Product Change Notification

E8T PCB Update

PCN-6514

Date of Notification	Change	Part Numbers Affected
May 15, 2018	☐ Major ☒ Minor	E8T Product Line

Figure 1, E8T PCB comparison showing existing design (left) vs. new board design (right).

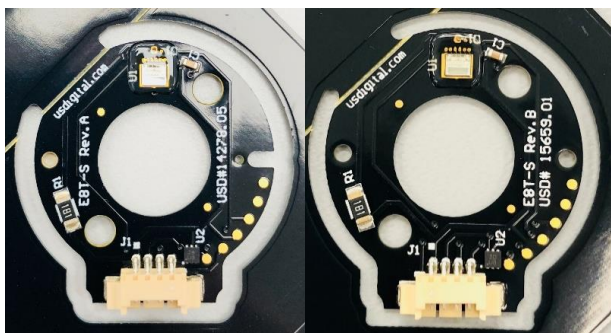
This notice is to inform our customers of a PCB design change that is being implemented for the entire E8T product line.

As part of our continuous improvement objective, the new PCB will improve overall product performance and enhance robustness of this product line. The new PCB has two mounting holes that mate with the base plate instead of one hole and one slot. This change has no impact on form, fit or function for the E8T.
